**ACTION TRANSMITTAL No. 2014-22**

**SUBJECT:** Scope Change Request for the Crystal Lake Regional Trail in Robbinsdale  
**REQUESTED ACTION:** Three Rivers Park District requests a scope change to modify the scope of SP#091-090-075 to increase the length by 0.4 miles, change the trail alignment, eliminate three bridges, change approximately 0.5 miles of the project from off-road trail to on-street facility with shared lane markings, and move the regional trail head facilities. The change would reduce the budget to a total of \$2,600,000 with \$1,840,000 in Surface Transportation Program (STP) funds (less than the \$2,163,200 originally programmed) and an increased local amount of \$760,000.

**SUBJECT: CRYSTAL LAKE REGIONAL TRAIL- ROBBINSDALE SEGMENT, ROBBINSDALE,  
MINNESOTA – SCOPE CHANGE REQUEST**

**Subject:** Crystal Lake Regional Trail (Robbinsdale Segment)  
Additional Information for Amendment Request  
SP# 091-090-075

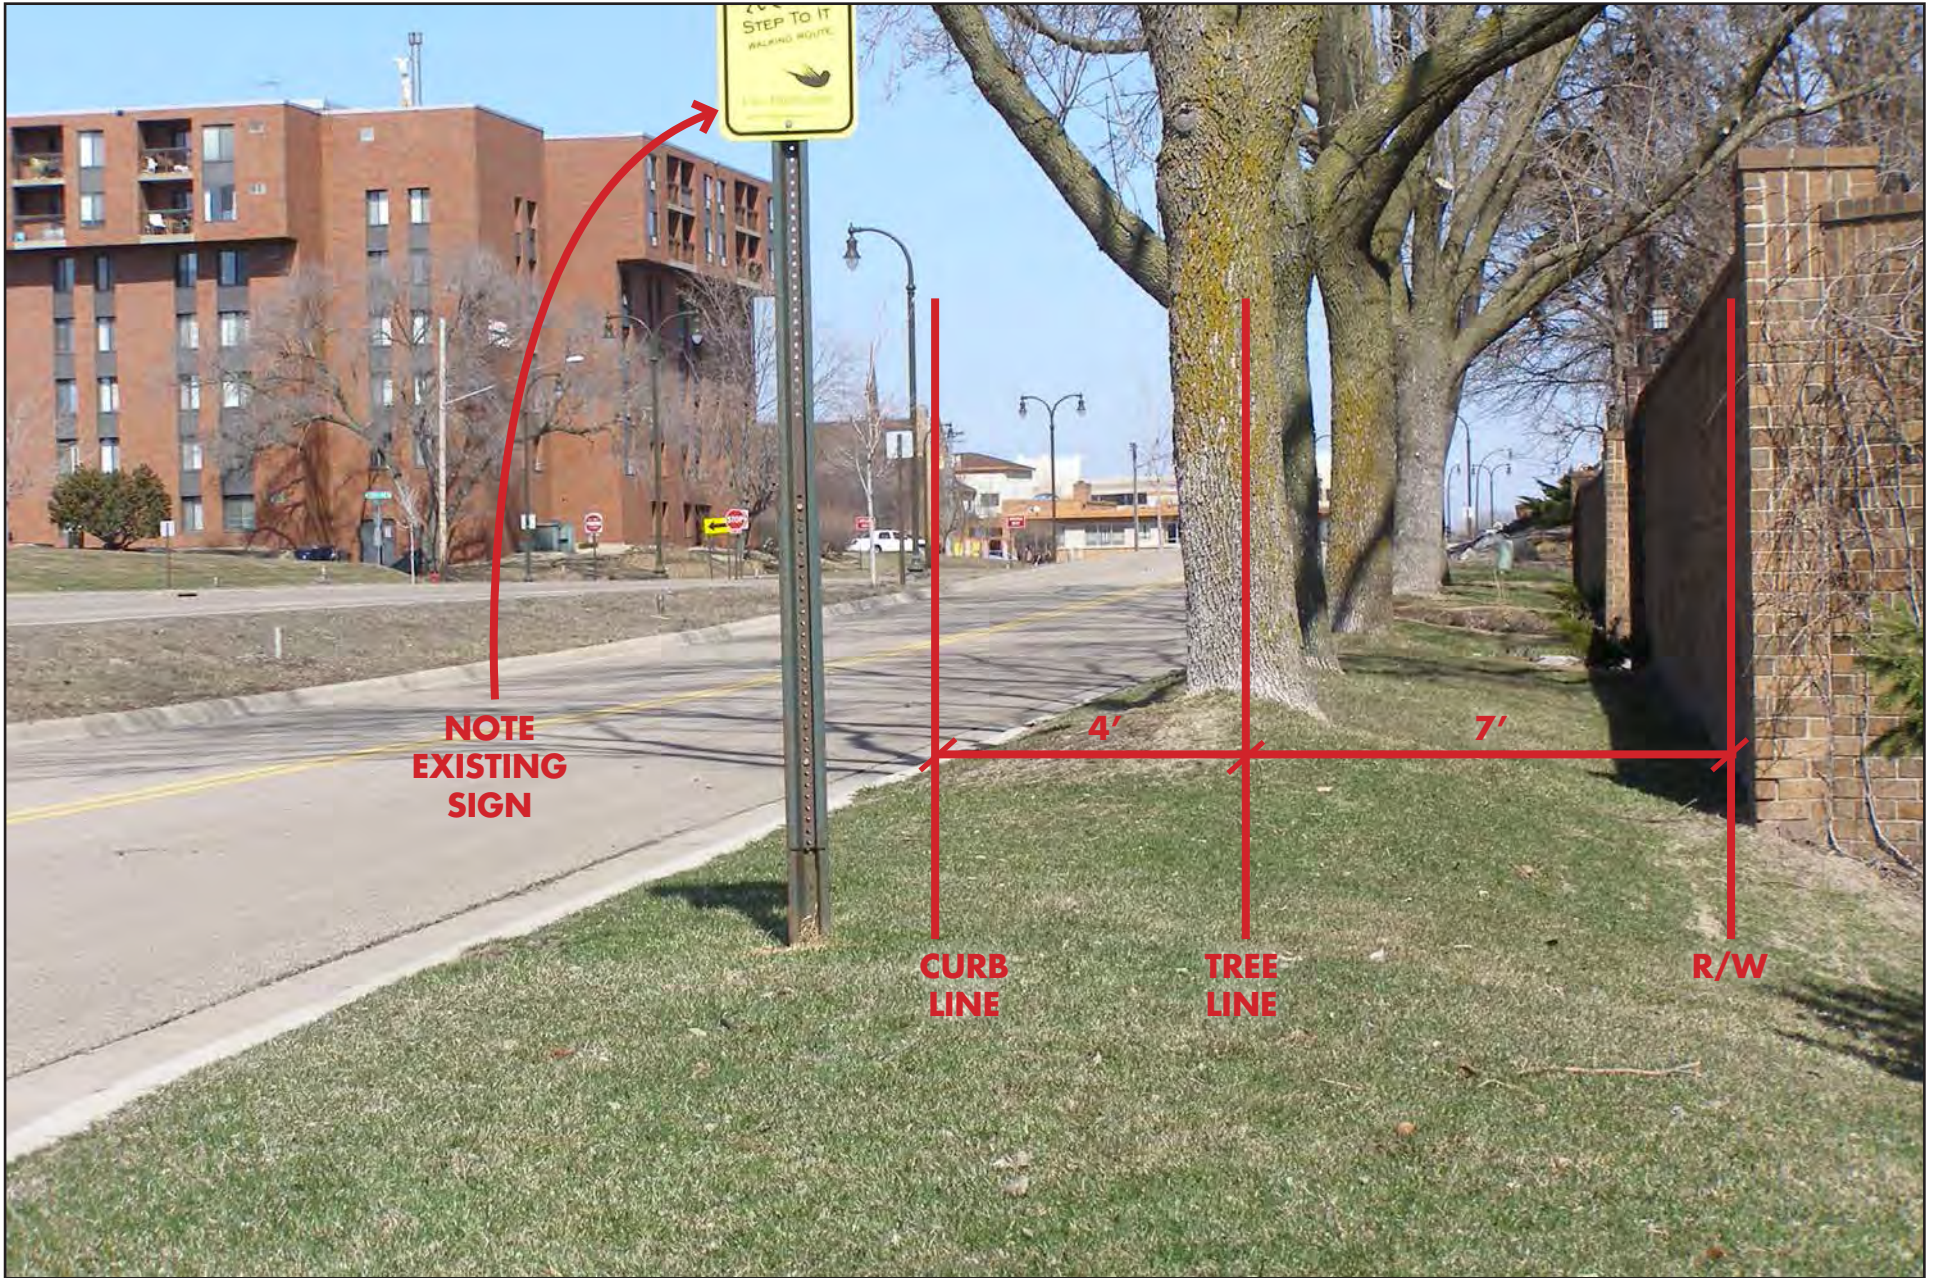
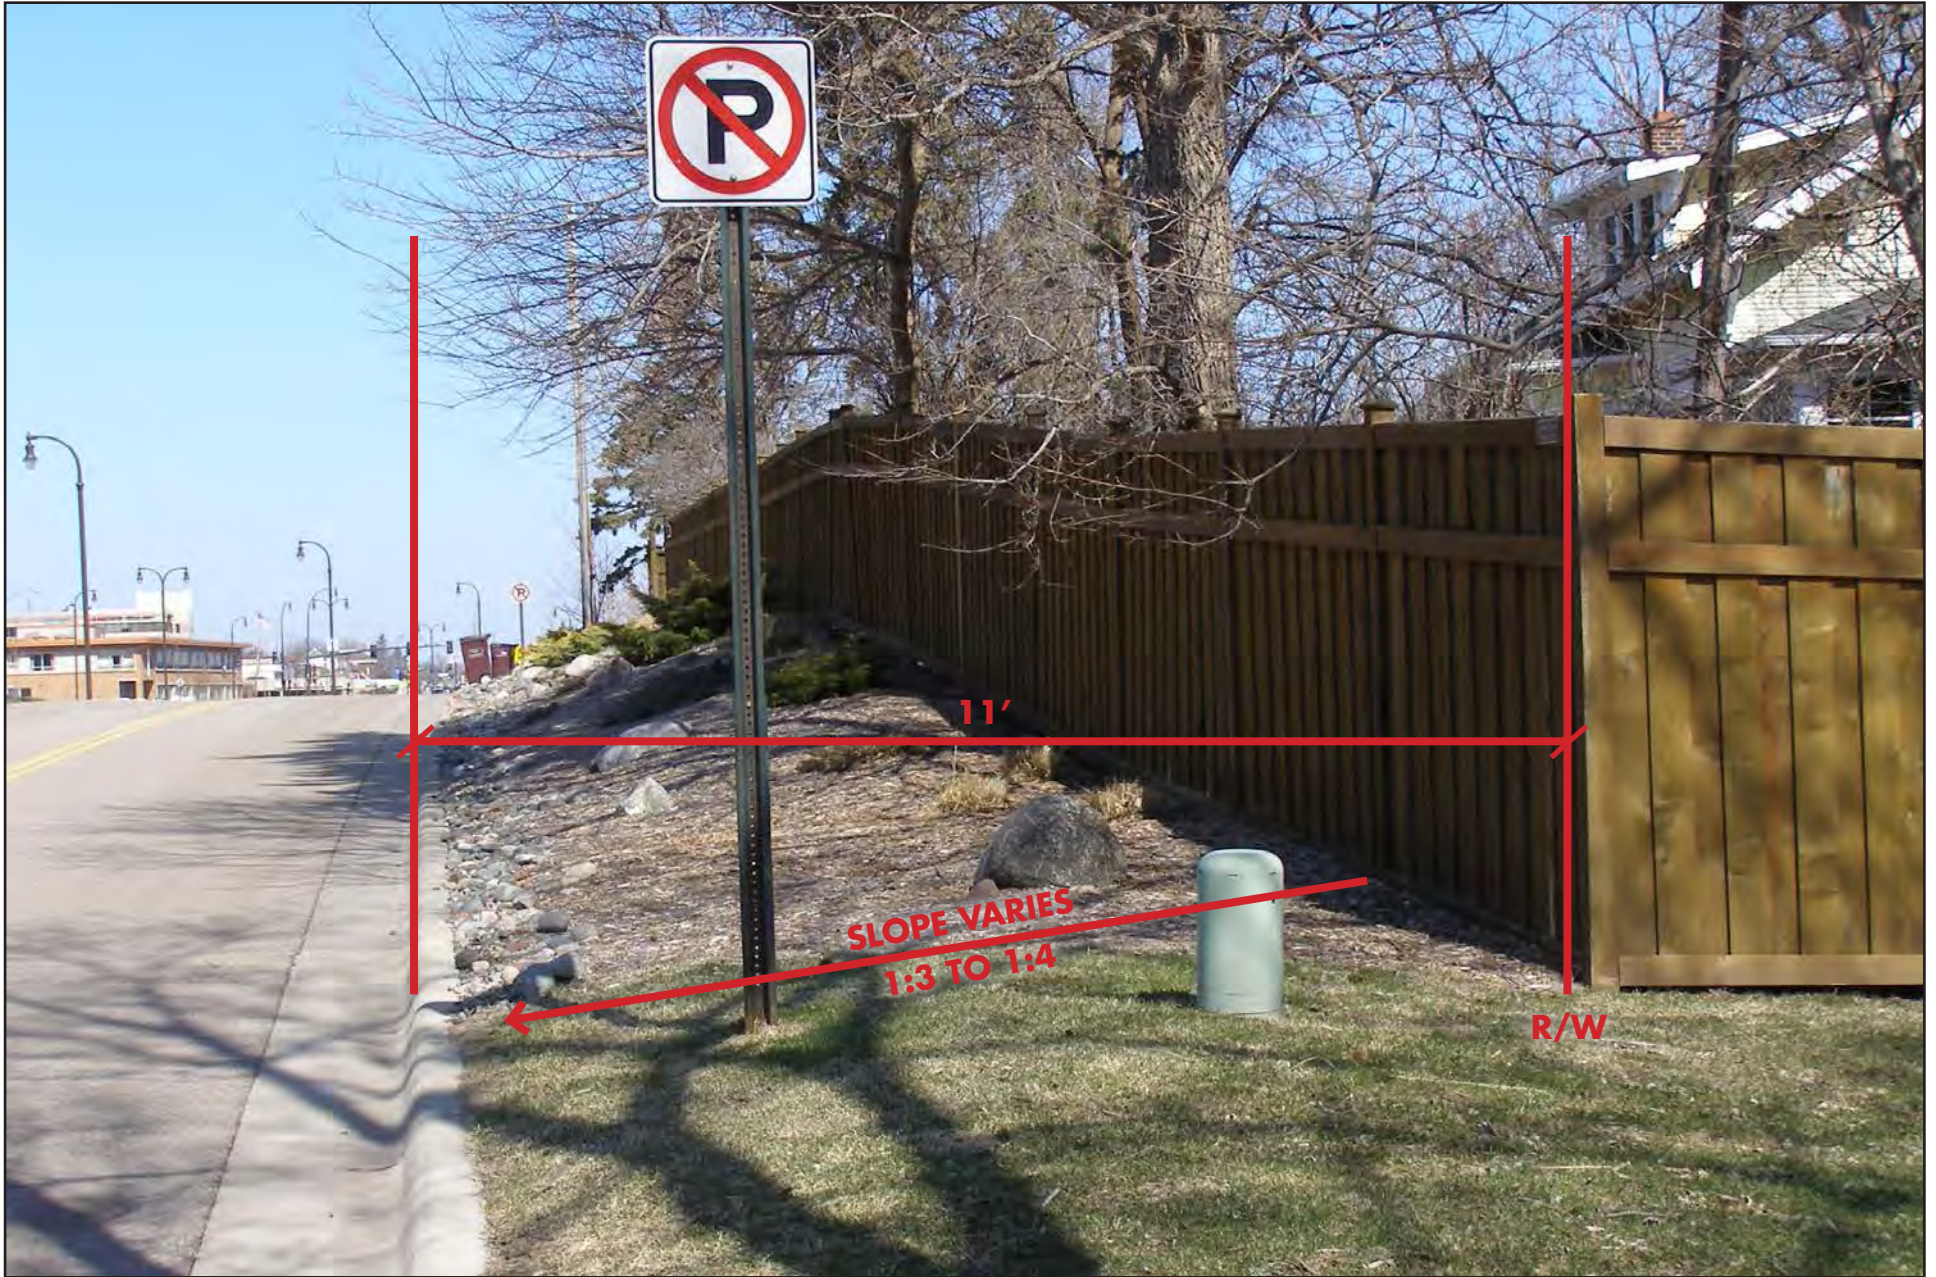
- Photographs (A, B and C) of the existing conditions adjacent to the condominium and first single family home north of the cul de sac) with key dimensions indicated on the images. All photographs are taken with a view to the north (CSAH 81 is on the left of the photos).

It should also be noted that because this is a cul de sac that serves a total of 13 residential units, it is estimated that the Average Daily Traffic (Vehicular) will be less than 100. Also note the existing sign on Photograph B (City of Robbinsdale Walking Route).

Because of the low volume of traffic, the difficulty in constructing a separated bicycle or pedestrian path/sidewalk in this area, and the existing pedestrian designation, Three Rivers Park District requests approval of the Amendment to the project scope and budget. It is our belief that the impact of constructing a separate facility for pedestrians and/or bicyclists would be significant, yet would not provide a benefit commensurate with those impacts (significant tree and landscaping removal as well as easement acquisition for construction). Additional wayfinding signs and markings will be included in the final plans for the project to provide appropriate guidance to the trail users as well as to provide awareness to those in motorized vehicles.

SHEET  
 48  
 OF  
 713

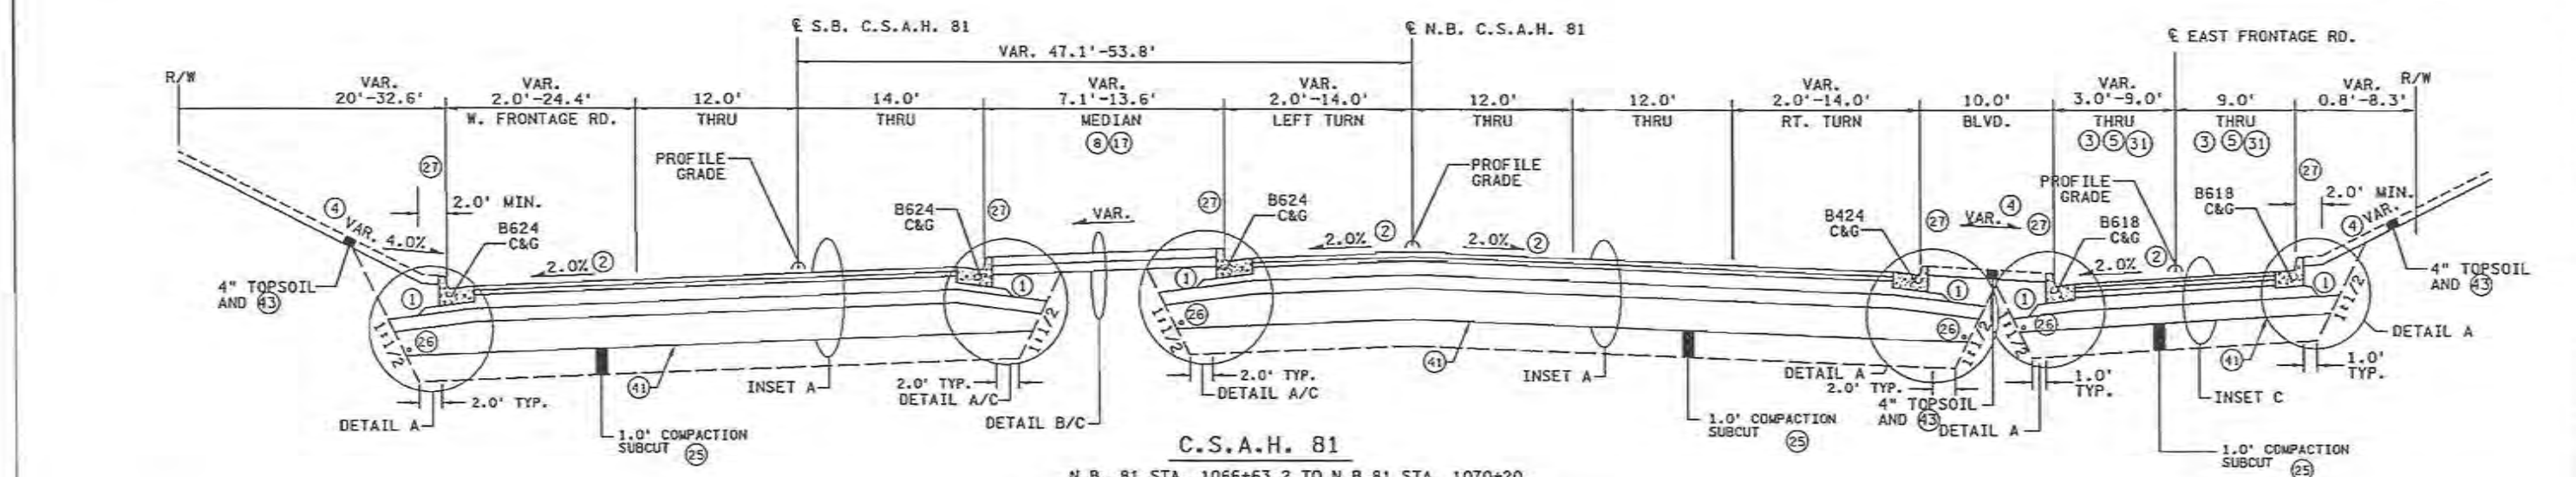
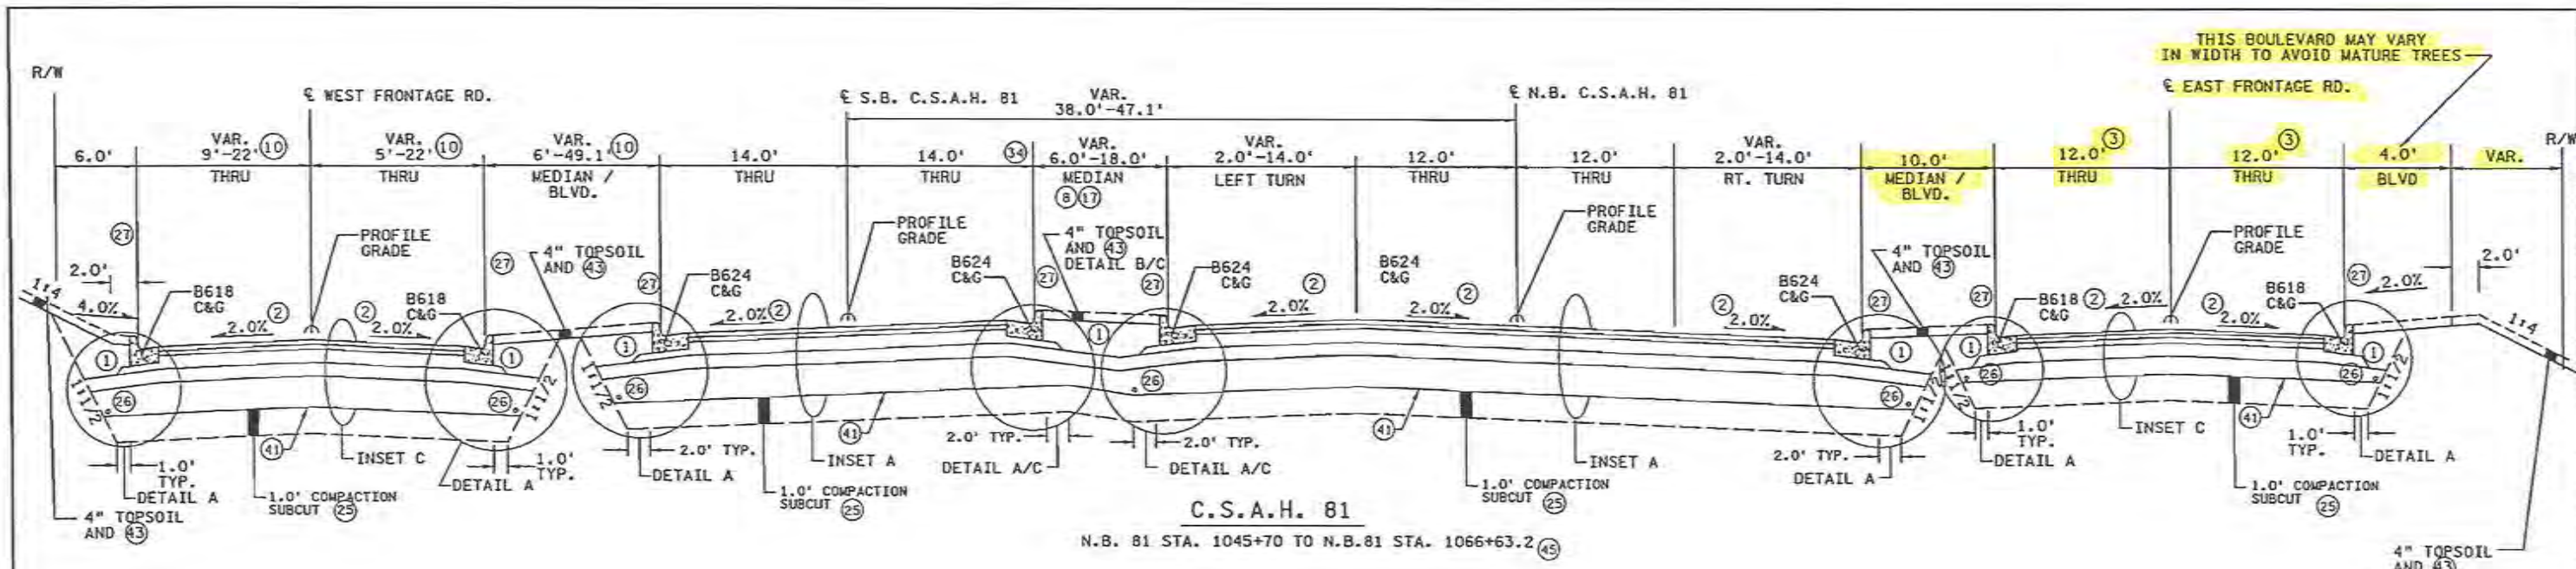
- Typical Sections from the CSAH 81 Reconstruction Project (Sheet 48 of 713) – Note the width of the frontage road and narrow boulevard between CSAH 81 and the East Frontage Road
